General Compliance DPP Meeting – November 27, 2024, 3:30pm

Gladwyn Townhouses, 11671 Cambie Road, Richmond BC [DP 17-772227]

Overview - DP vs As-built Differences

B. Outdoor privacy screens extended past entry canopies

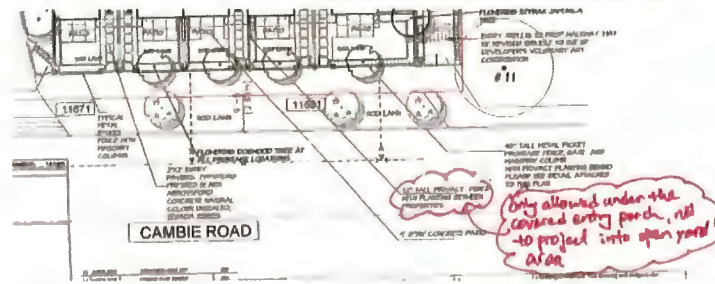
The approved DP noted in red that the 72" privacy fences cannot project into the open yard past the covered entry porch. However, it was an oversight that the taller fences extended past the overhanging entry canopies. To rectify, the 6'h wood lattice dividers have been reduced to 4'h.

Similarly, along the Mellis Drive PROP pedway, the approved DP set notes that 6'h wooden dividers are only allowed under the covered entry porch, not to project into the open yard. Again, an oversight not working from this DP set, the 6'h wooden dividers do extend past the shallow canopies but help to visually screen the patios. They also provide a solid noise barrier for the condenser units in each yard. After city review, these are left at 6'h tall.

C. Canada Post: advised would not install mailbox with manhole casting in front (hazard)

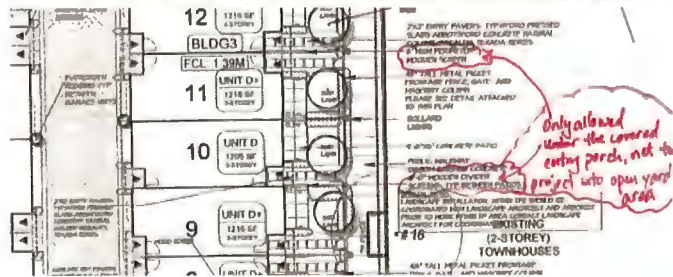
Canada Post required that the mailbox kiosk be relocated to the south of Building 5 from west of Building 1 – due to the presence of a manhole cover (accessing an underground pipe) at the proposed location. It was deemed a potential tripping hazard and not acceptable for mail workers. Consequently, the proposed live planting was relocated to other parts of the site.

D. Drive aisle crossing was not raised – speed bumps added in lieu

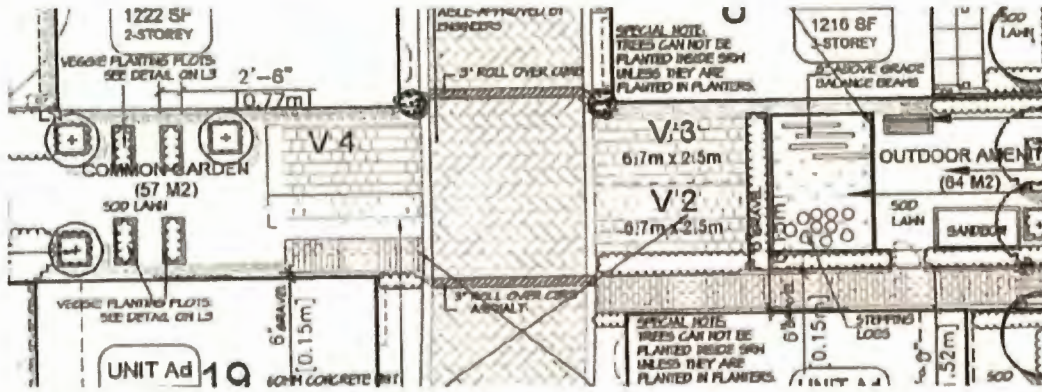
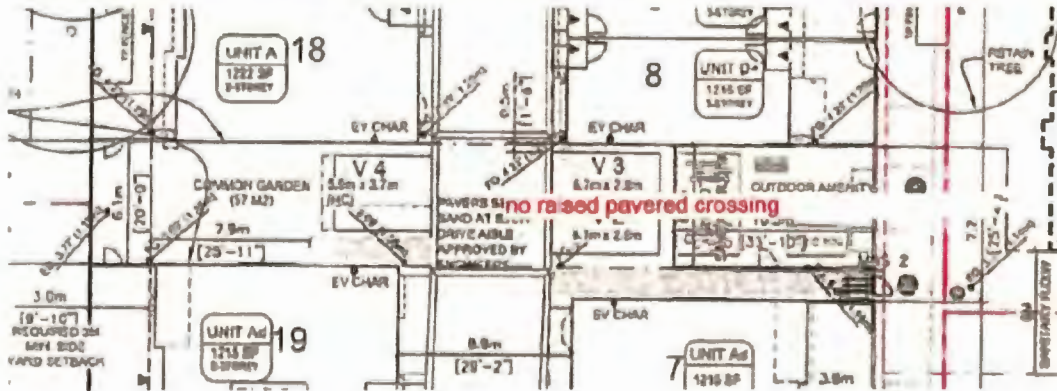
The approved DP landscape drawing correctly noted the 3" rollover curbs but the approved arch DP drawings do not. Somehow, the note for the raised pedway was inadvertently dropped.

E. Revised some cladding materials to suit marketing team concerns

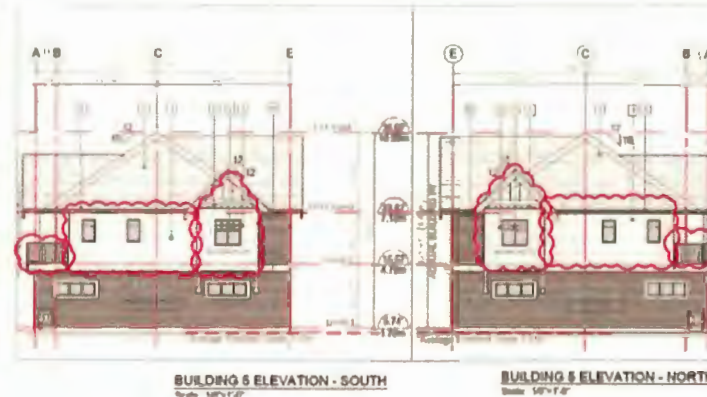
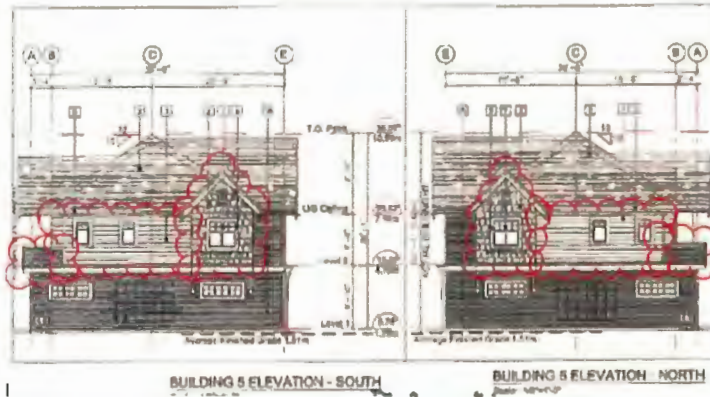
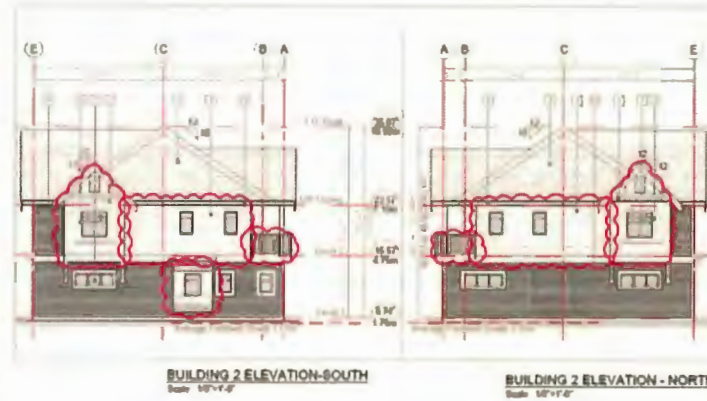
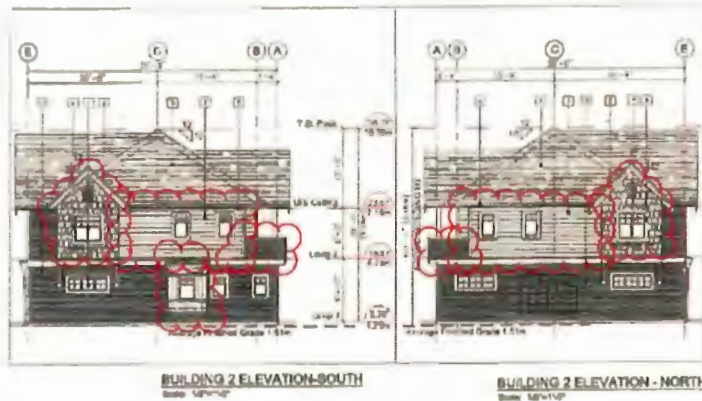
A few adjustments were made to the exterior materials that were proposed by the marketing team, but we also supported as improvements to the project:

- a) Change from fibre-cement shingles to board & batten.
- b) Colour change to minor sections of horizontal 8" Hardie plank siding from BM CC-80 (gray mist) to an off-white tan colour. The gray was deemed too dark for the market.
- c) Colour change of entry doors from bright red (BM CC124) to more muted darker red/brown.
- d) Building 2&5 balcony pony wall was changed to aluminum guard rails
